Design Advisory Board

DAB Agenda - Tuesday, September 12, 2023, 3:00 PM, 645 Pine Street, Front Conference Room or Remote on Zoom

MEMORANDUM

To: The Design Advisory Board
From: Mary O'Neil, AICP, Principal Planner
RE: ZP-23-98
Location: 41 Kingsland Terrace
Date: September 12, 2023

DONOVAN- MITCHELL ADU PROPOSED ELEVATIONS

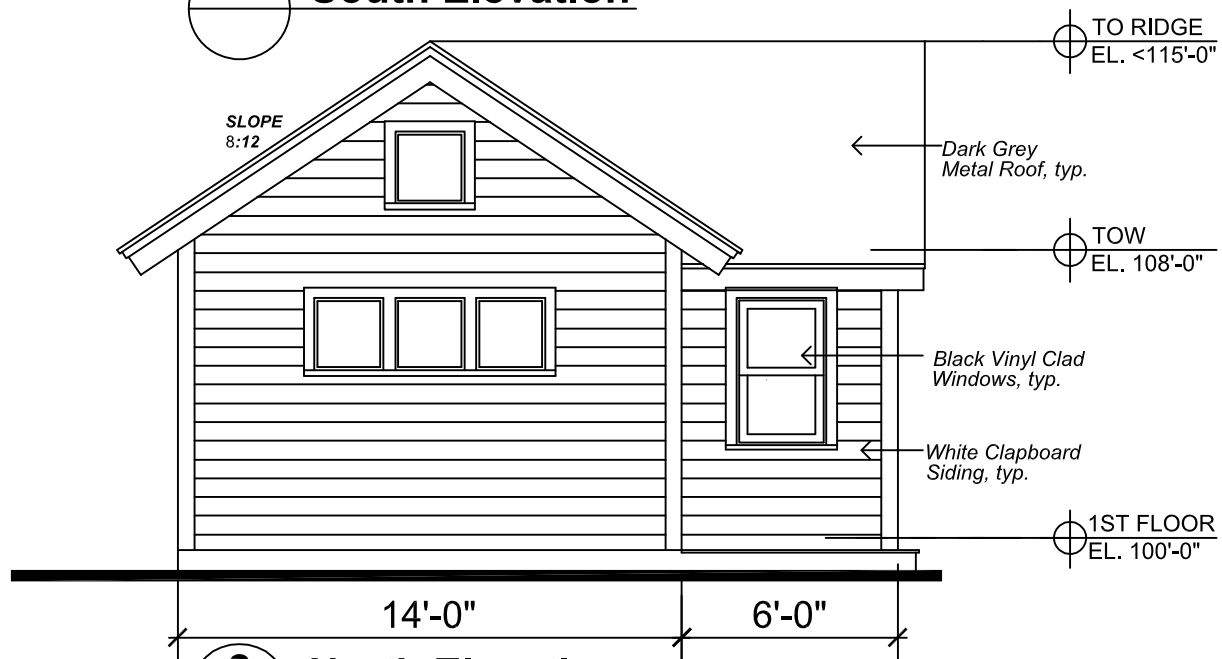
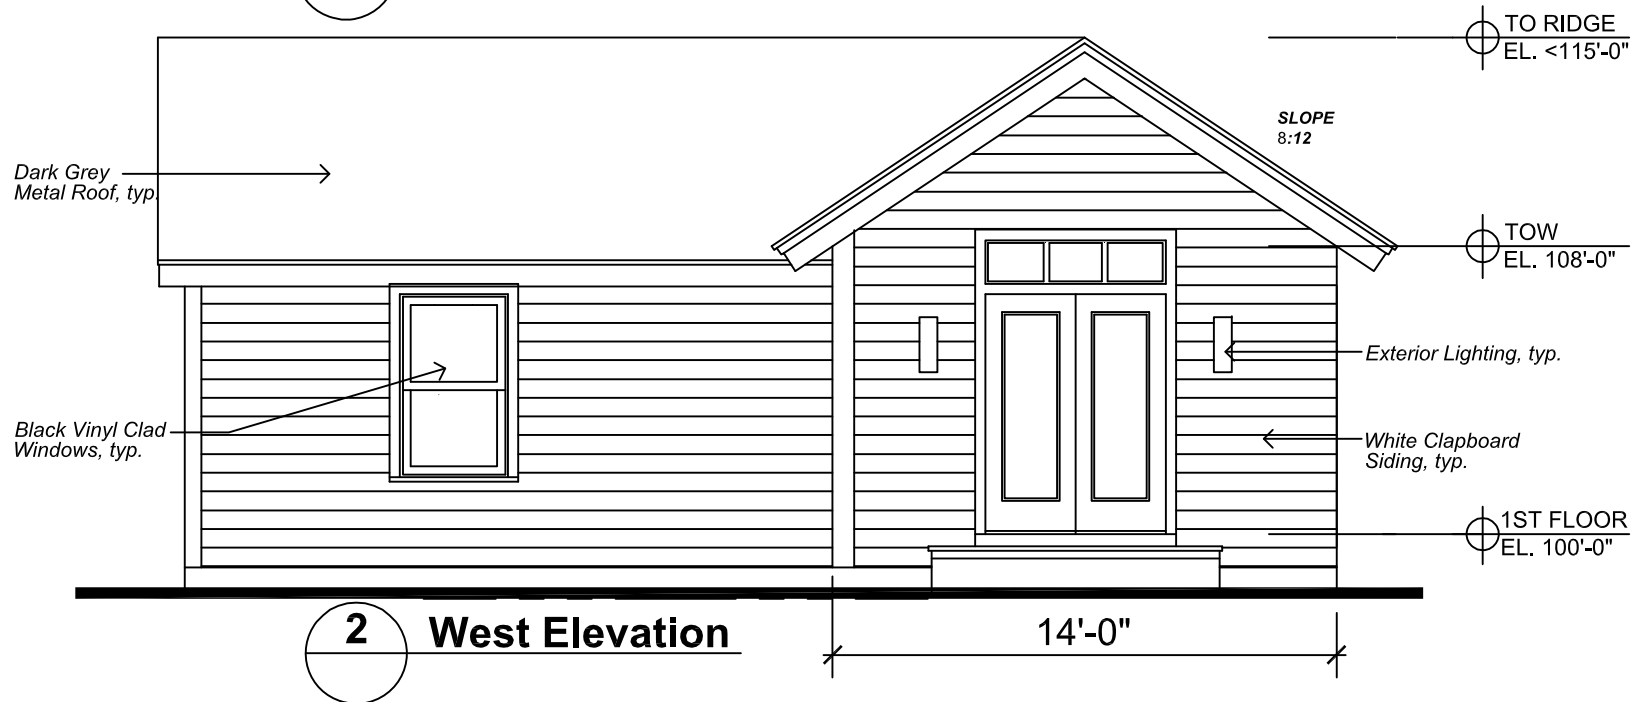
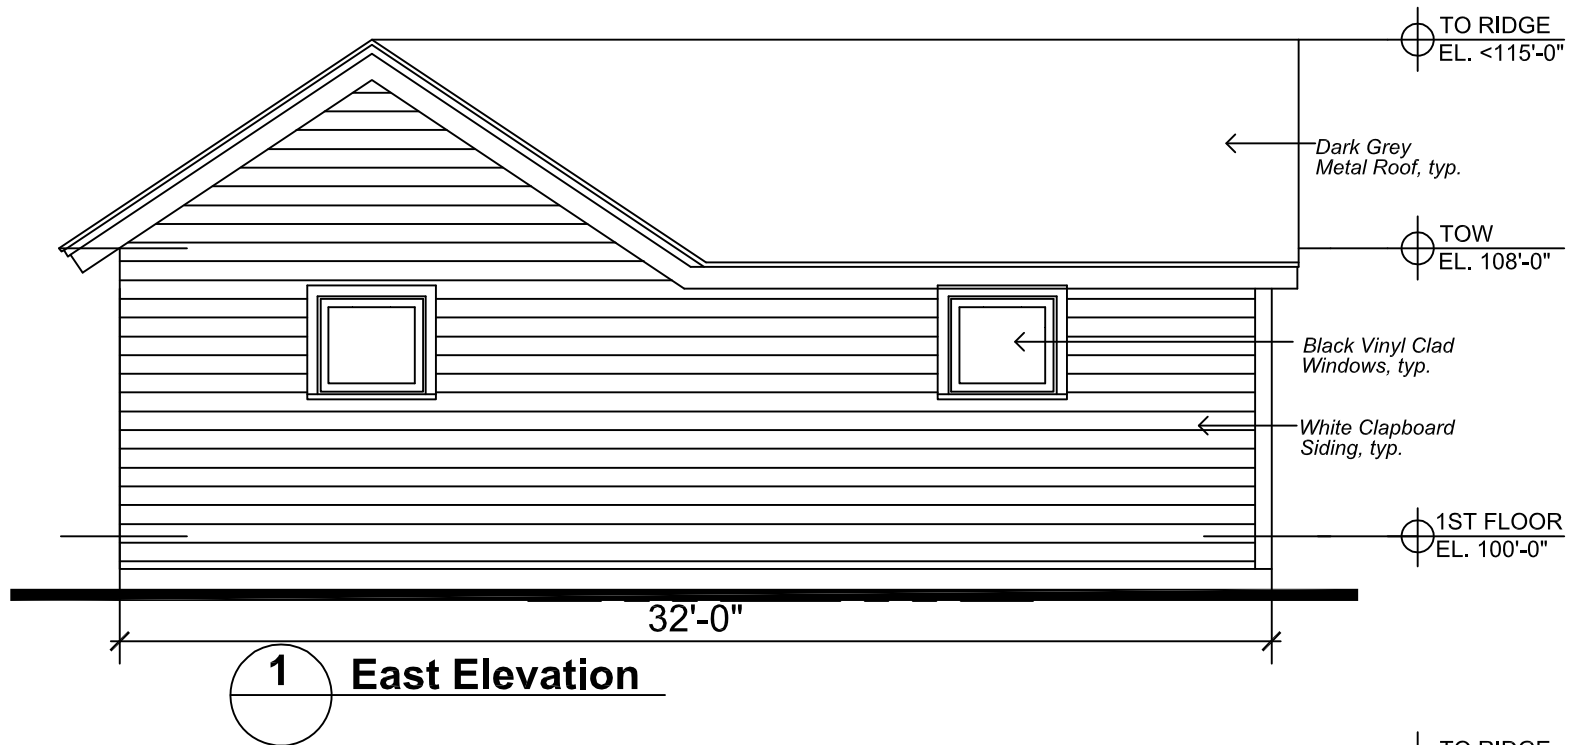
1. An Erosion Prevention and Sediment Control Plan shall be required.
2. A pedestrian path to the ADU shall be illustrated on the site plan.
3. A landscaping plan is required.

4. The plan does not include any information about meters, mailbox, utility connections, or any mechanical equipment. All should be identified on the site plan and/or building elevation as appropriate. Condensing units, if included, need to meet required setbacks.
5. The applicant shall provide items 5.4.8 d) 1. A-C for DRB review.

C2.0

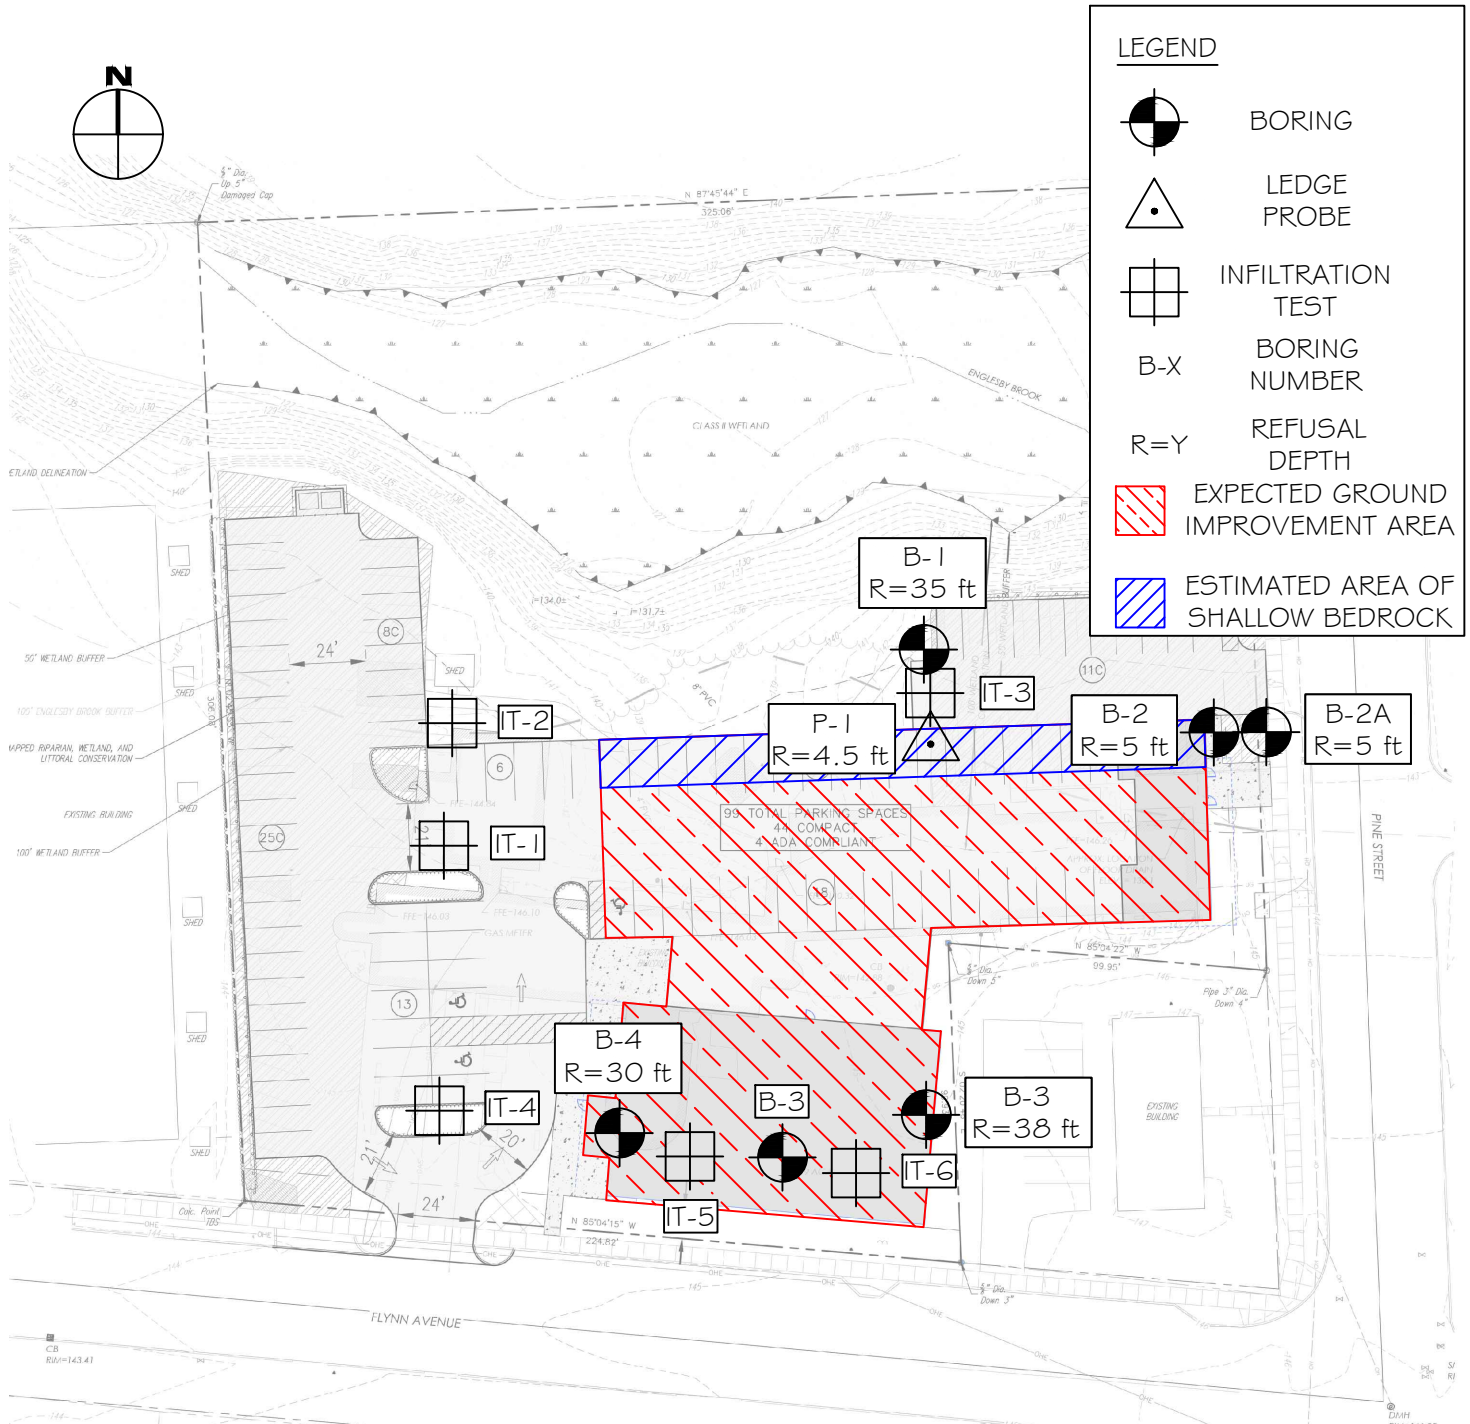
There are protected entries on both Flynn Avenue and Pine Street. Snow storage is located on the site plan. (Plan C2.0. Snow storage is identified as C14.) **Affirmative finding.**

Vehicular access is available at both street frontages, with a designed circulation path illustrated on plan C2.0.
